ORIGINATION FORM

Proposed Revisions to a Standard Plans Index (Please provide all information — Incomplete forms will be returned)

Index Number: 700-106
Sheet Number (s): 1 & 2
Index Title: Rural Narrow Bridge Treatment

RURAL NARROW BRIDGE TREATMENT

INDEX 700-106	SHEET 1 of 2
-------------------------	------------------------

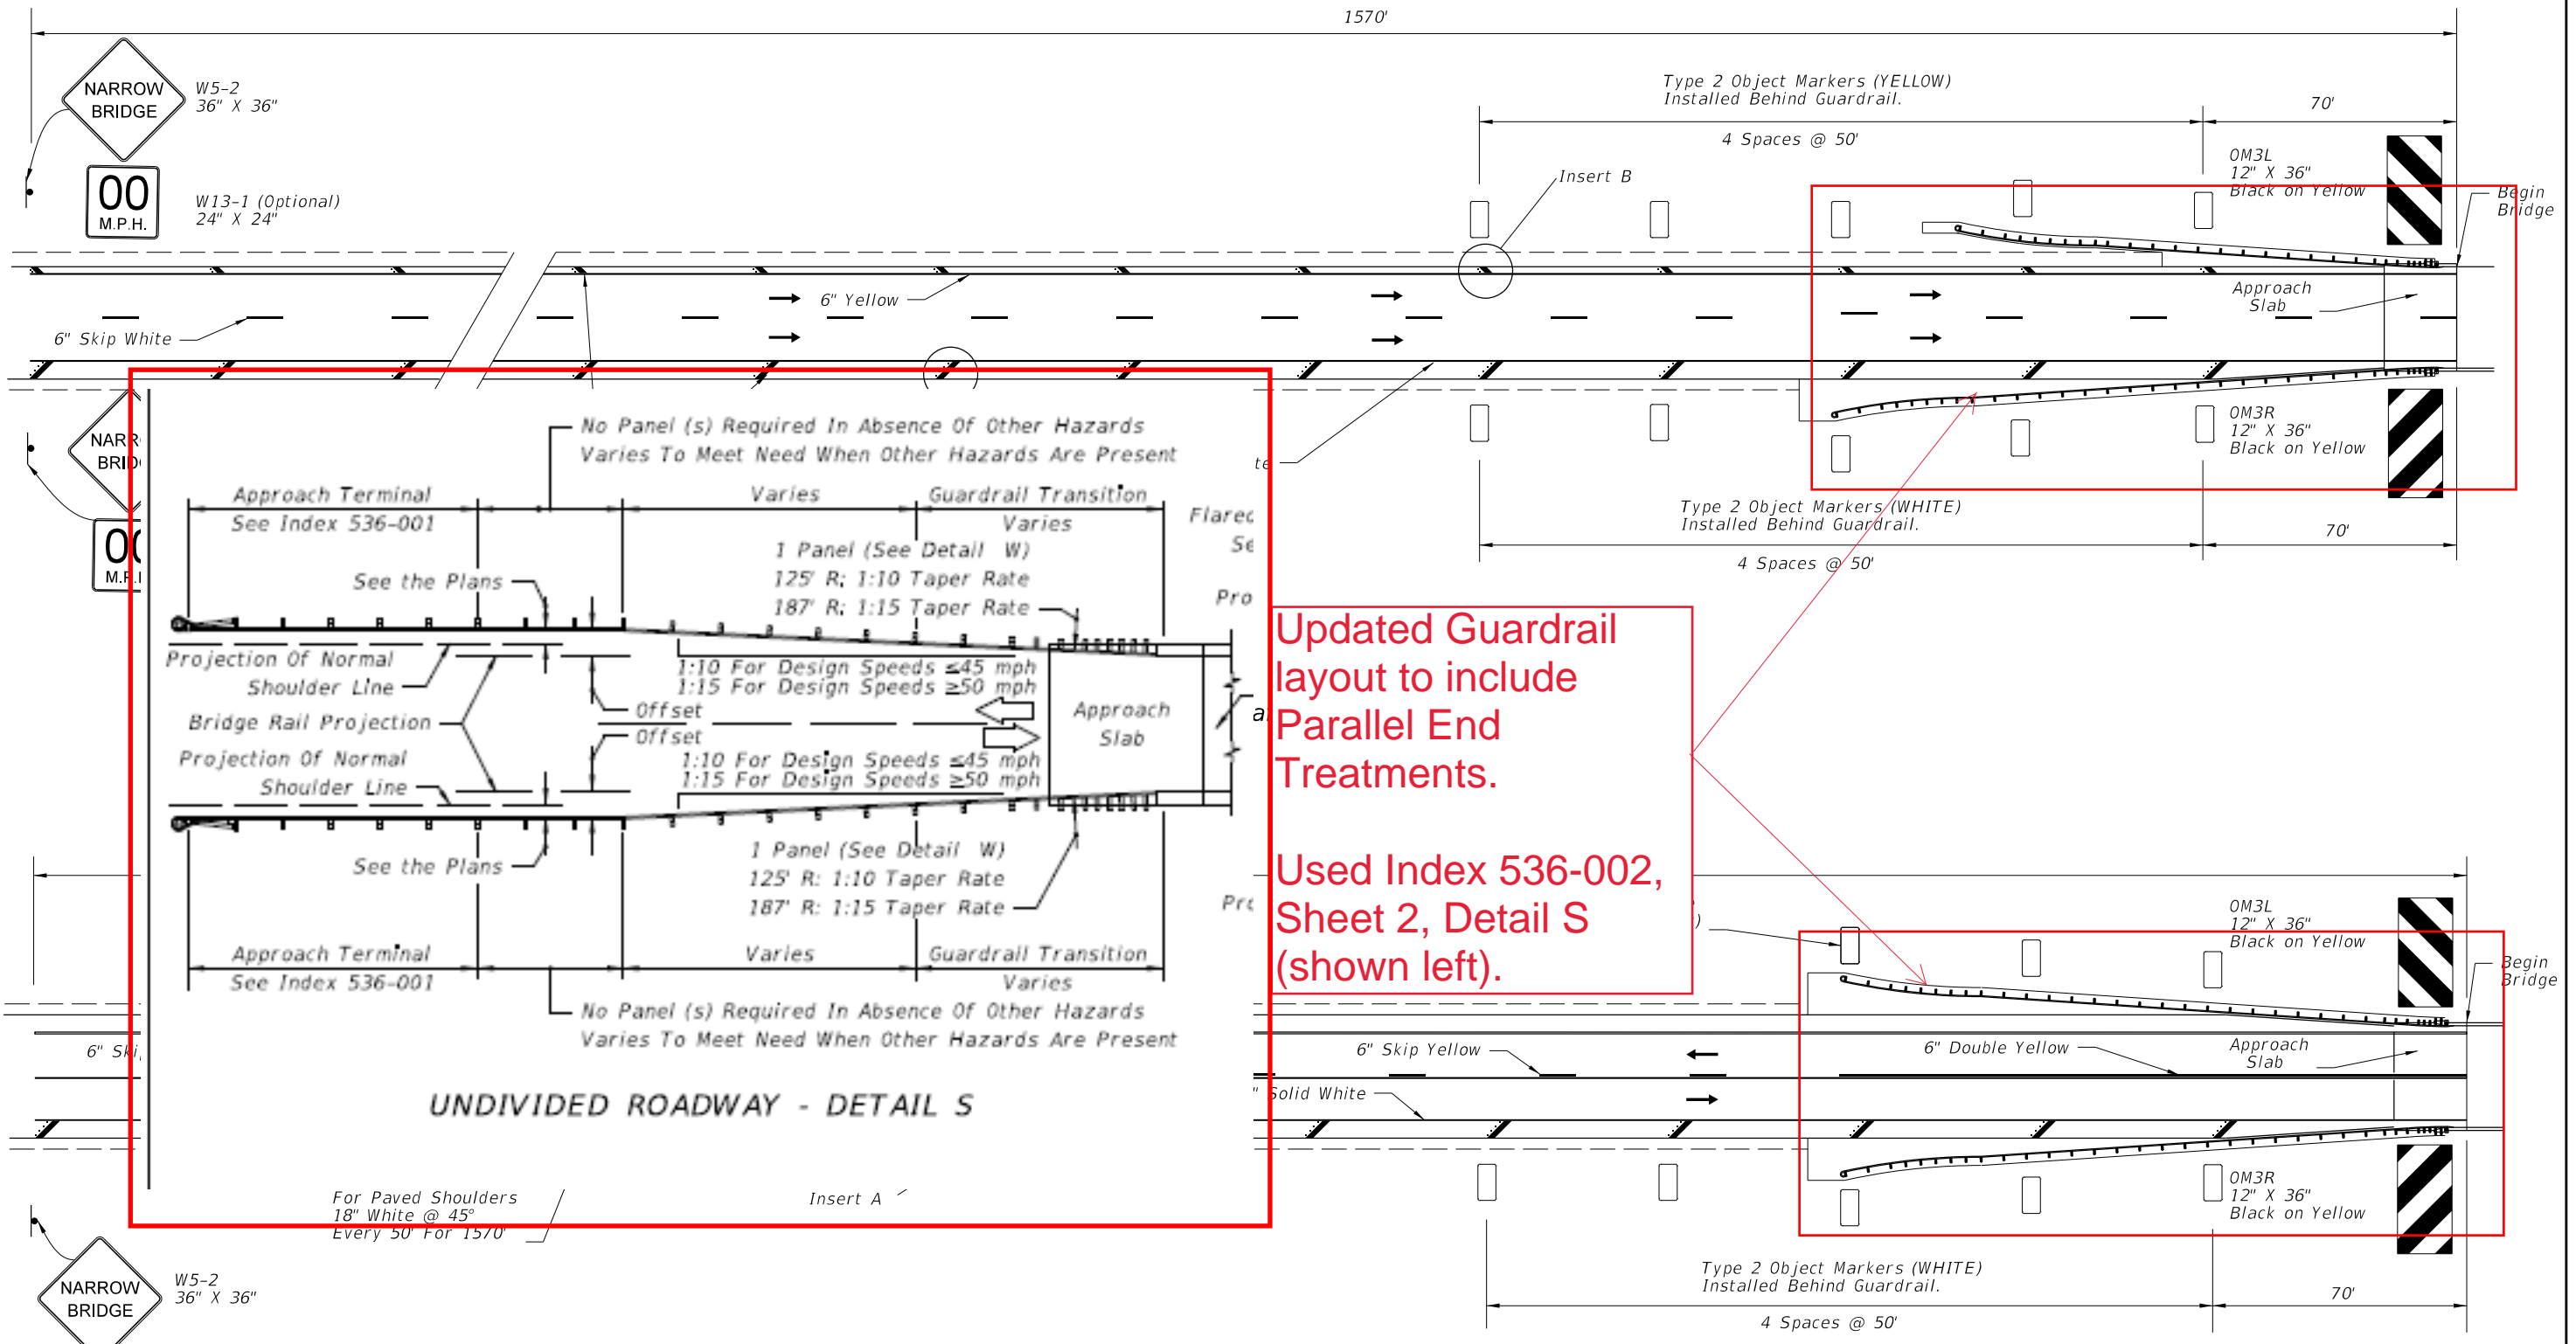
Sheet 1: Updated the guardrail layouts illustrated to include Parallel Approach Terminals.

Updated Guardrail layout to include Parallel End Treatments.

Used Index 536-002, Sheet 2, Detail S (shown left).

The Department no longer uses Flared Approach Terminals for new installations of guardrail; therefore, for consistency with Index 536-001 details, the layouts shown on Sheet 1 are updated to show Parallel Approach Terminals. Sheet 2 references to Rumble Striping were removed for consistency with current policy (RDB18-03).

SHEET
2 of 2

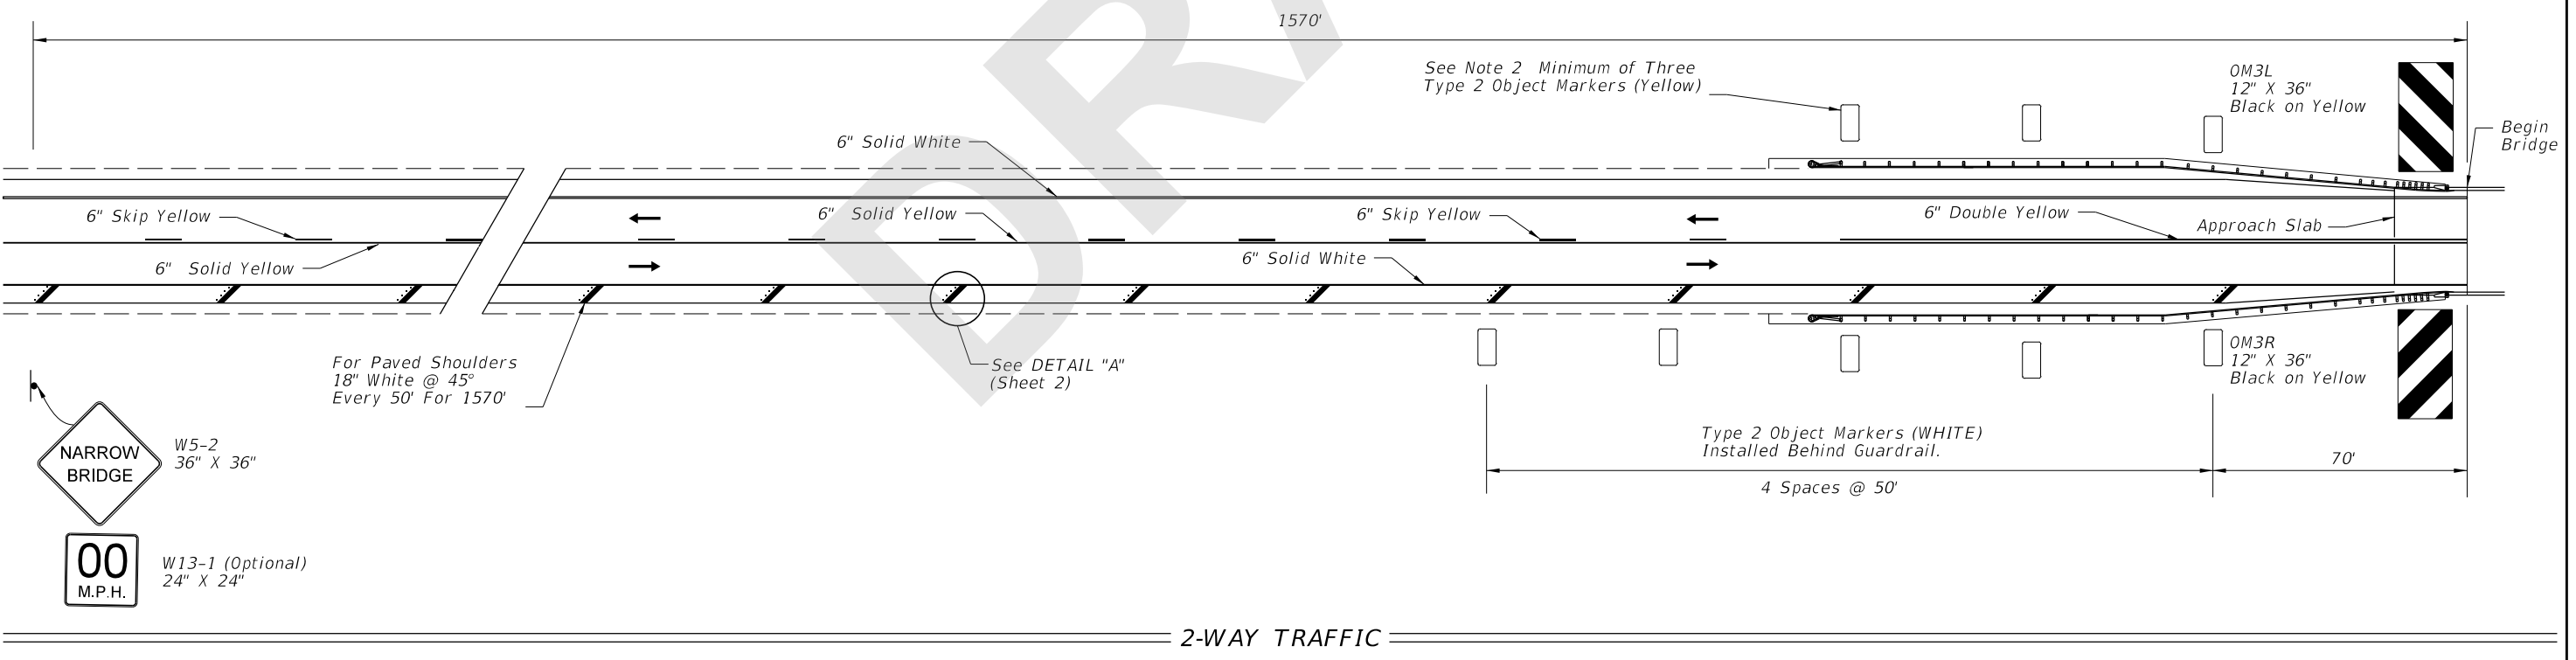
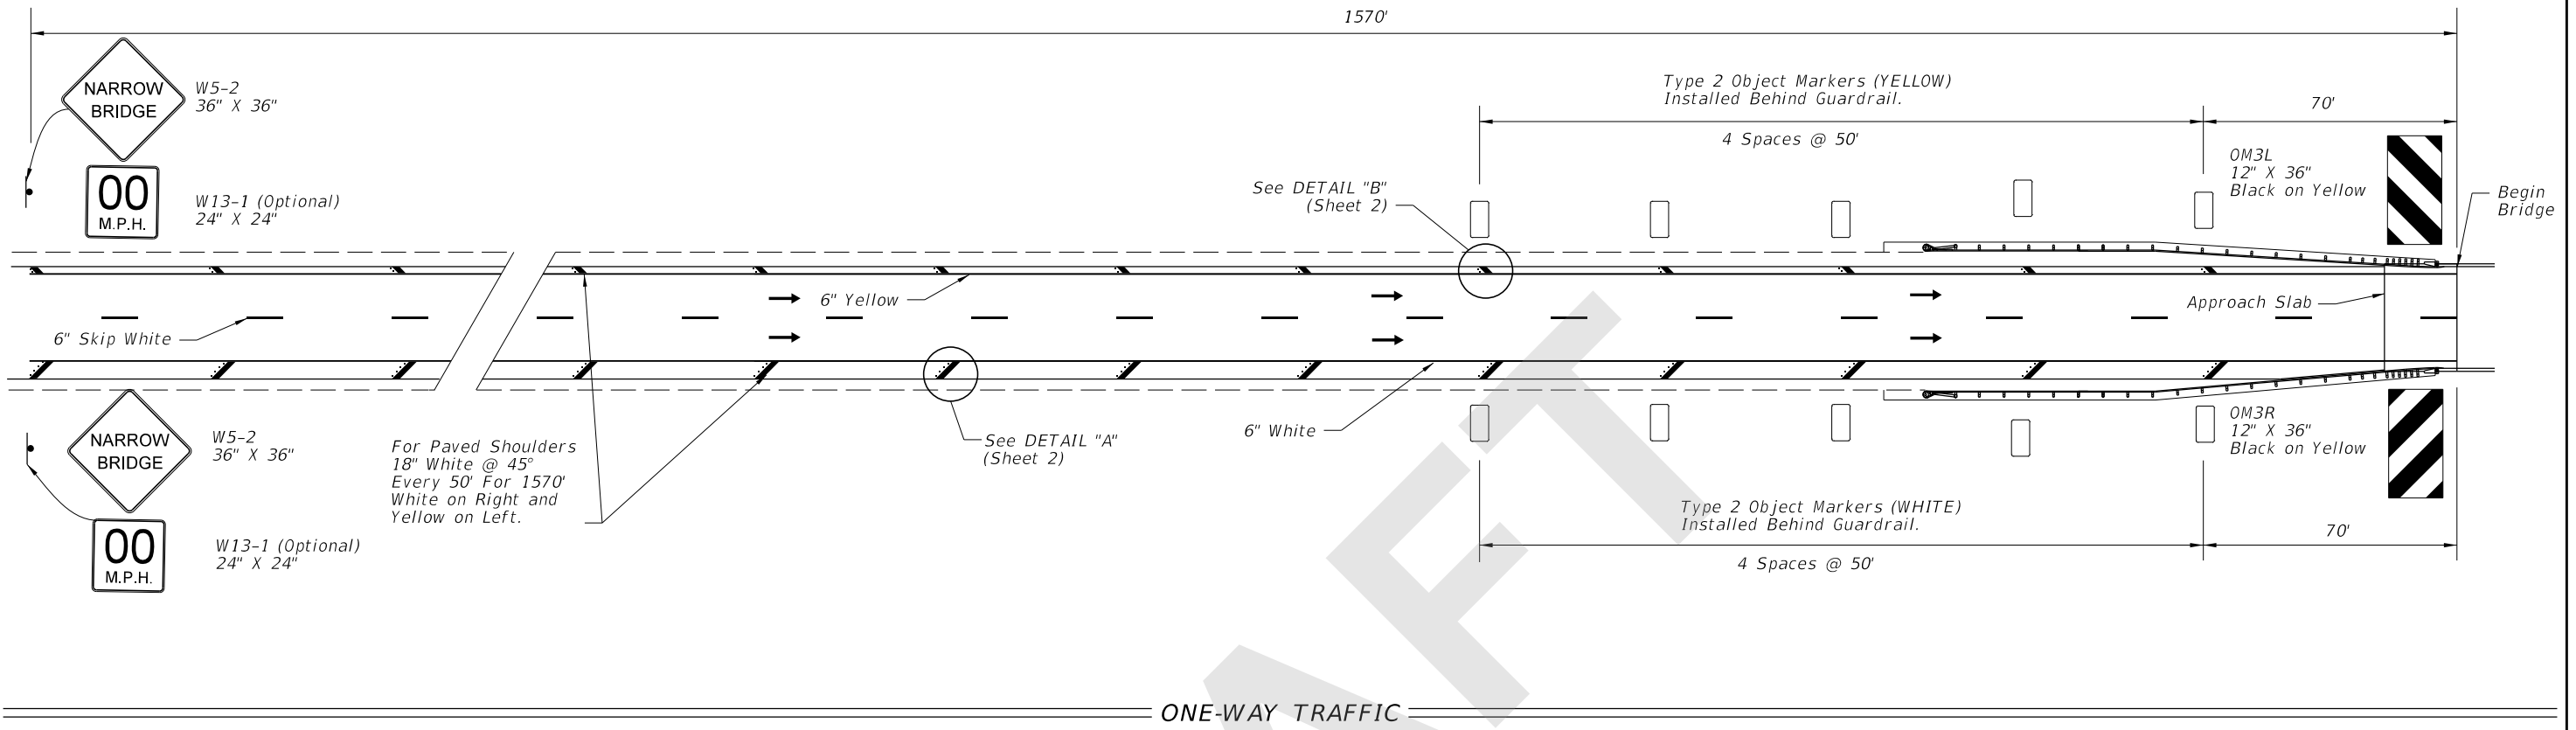
Sheet 2: Removed call-out references to the Rumble Striping and Profiled Thermoplastic in the 'INSERT A' and 'INSERT B' details. Added new Note #5, to refer to the Plans for the installation Audible and Vibratory treatments.

Added Note 5

5. Install Audible and Vibratory treatments (e.g., ground-in rumble strips or profiled thermoplastic) in accordance with the Plans.
